ITEM FOR ENVIRONMENTAL COMMISSION AGENDA

NAME & NUMBER OF PROJECT: BKO Parmer (SP-2021-0034D)

REQUEST: Variance request is as follows:
Request to vary from LDC 25-8-342 to allow fill over 4feet up to 12feet.

Development Services Department
Staff Recommendations Concerning Required Findings

BKO PARMER
 CUT FILL EXHIBIT
 4801 EAST YAGER LANE
 AUSTIN, TEXAS

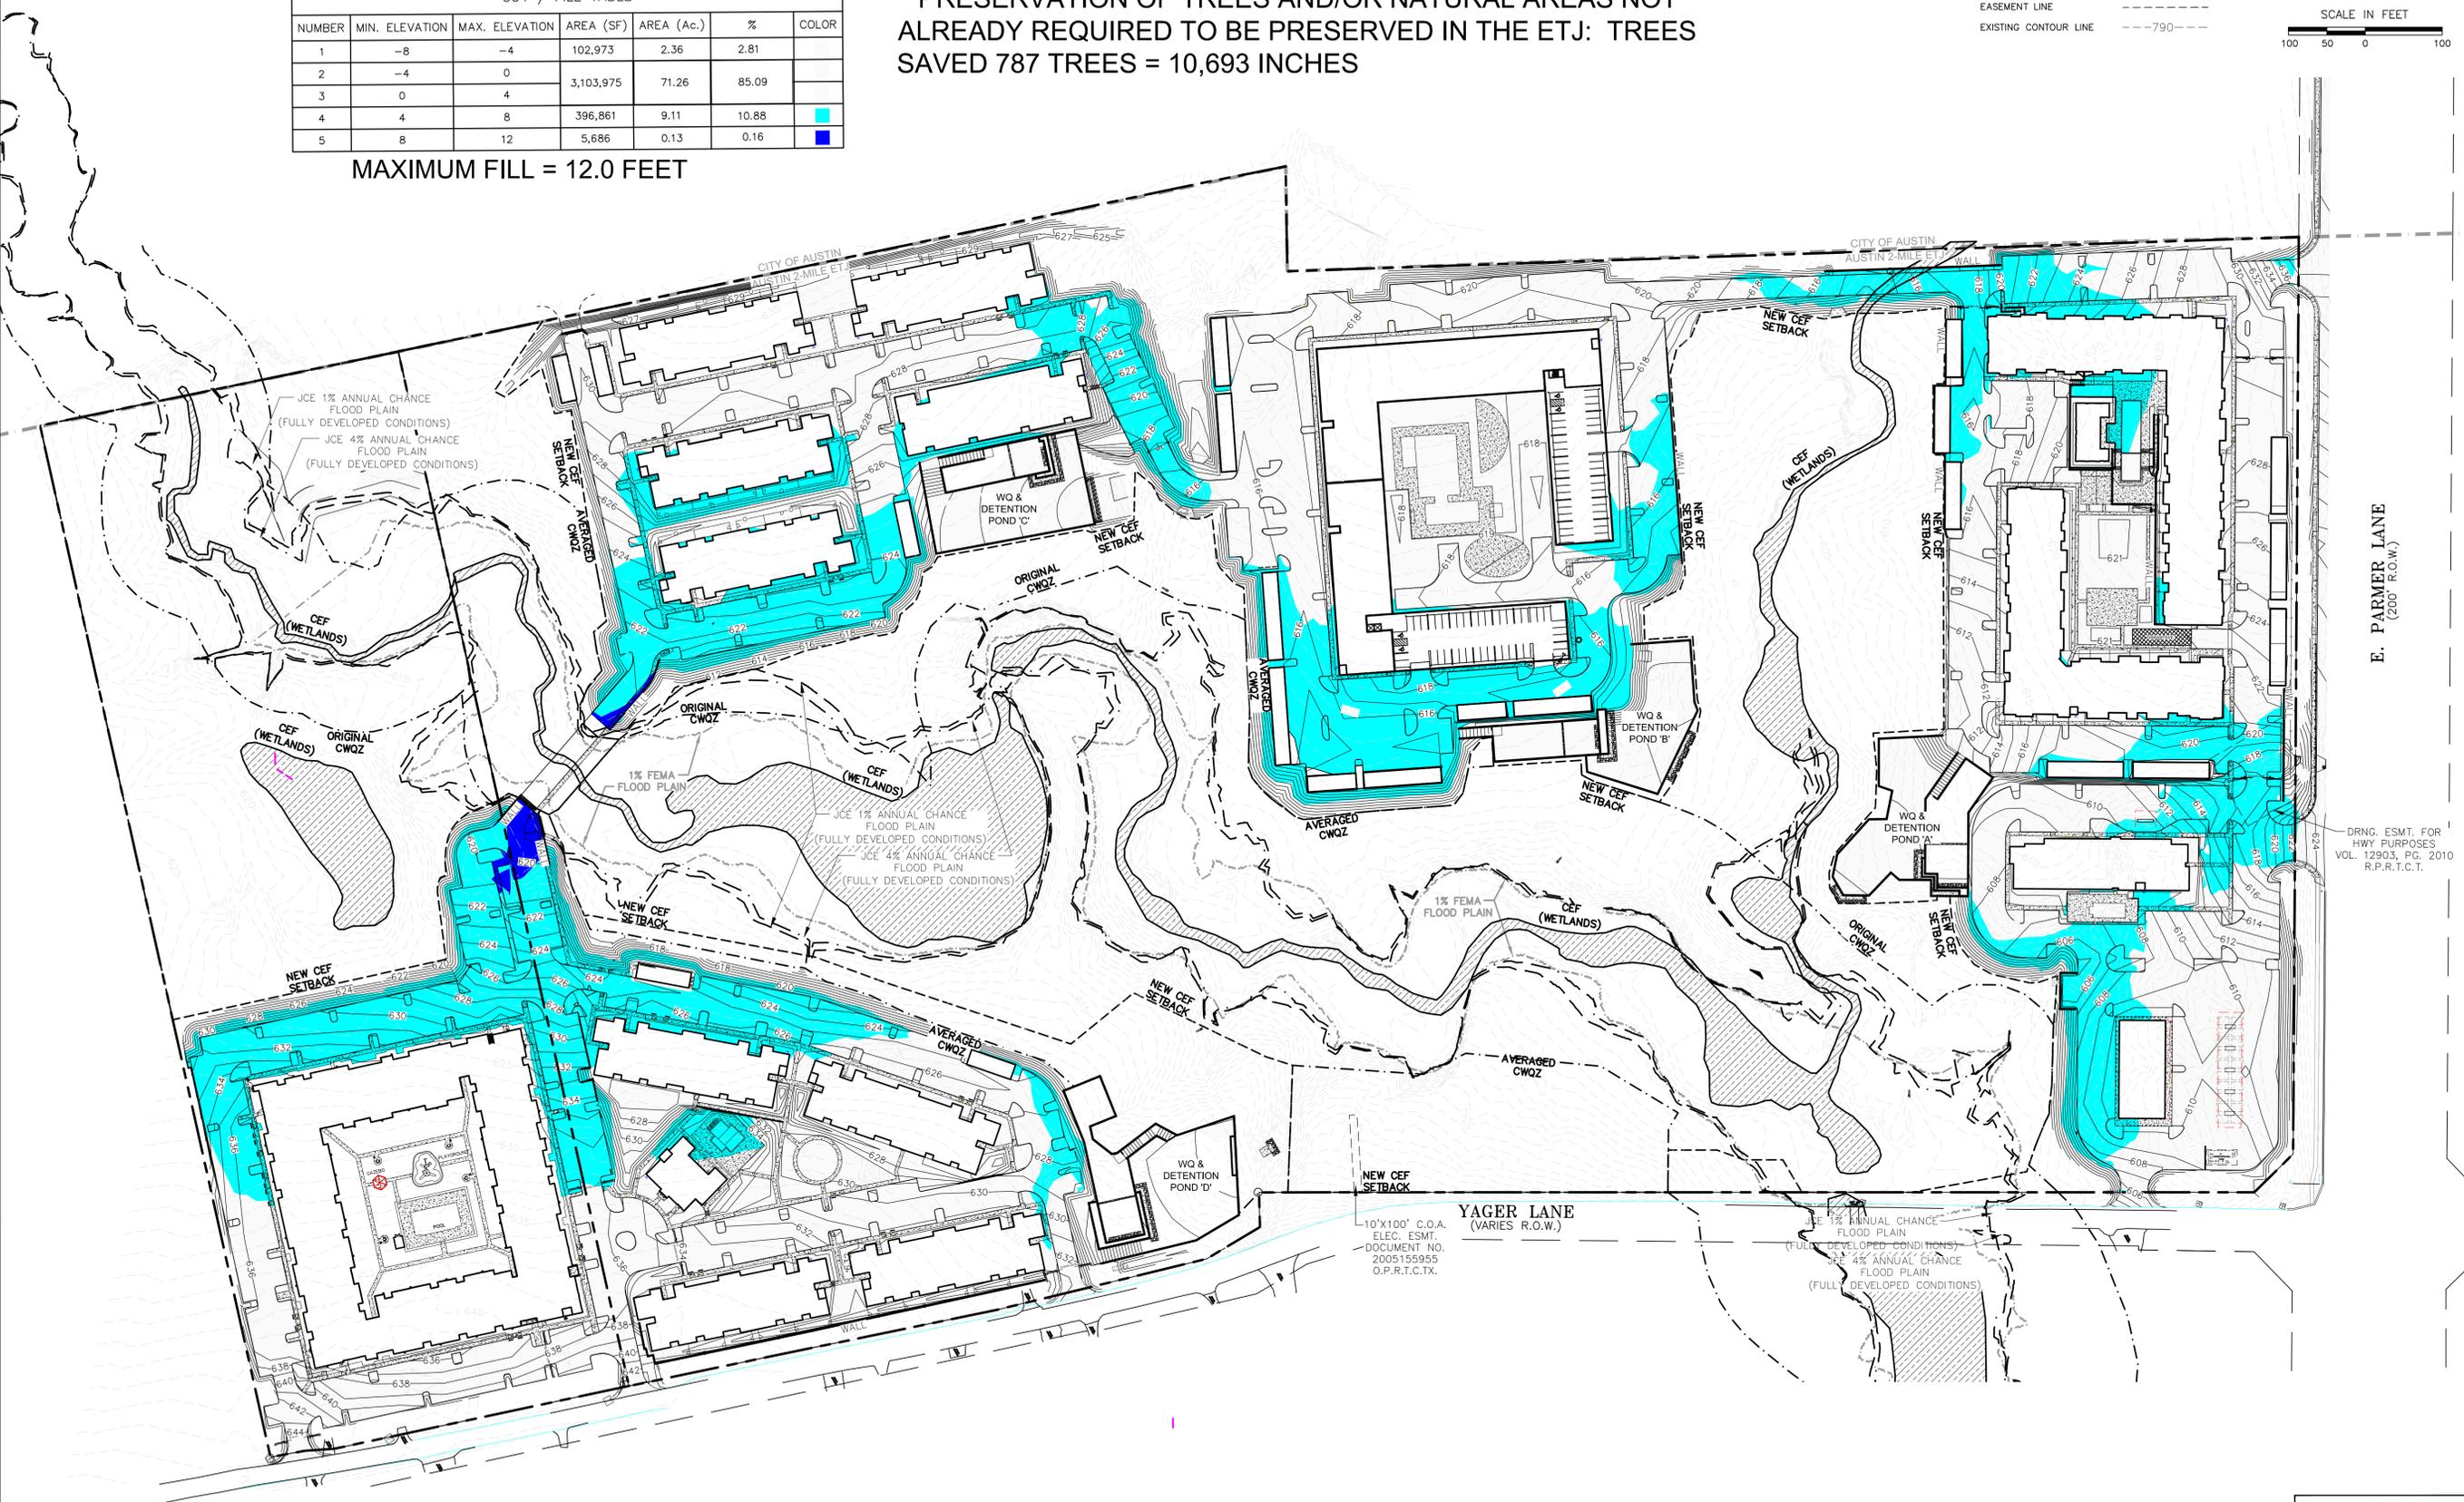
Yes. The variance does not create a significant probability of harmful consequences. The variance is a minimum deviation from code to allow for reasonable use of the property. Fill will be minimized and structurally contained with a retaining wall.

MAXIMUM FILL = 12.0 FEET

- Preserve trees/natural areas.
- Apply City of Austin Landscaping Ordinance on ETJ site.
- Provide structural containment of fill with a retaining wall.
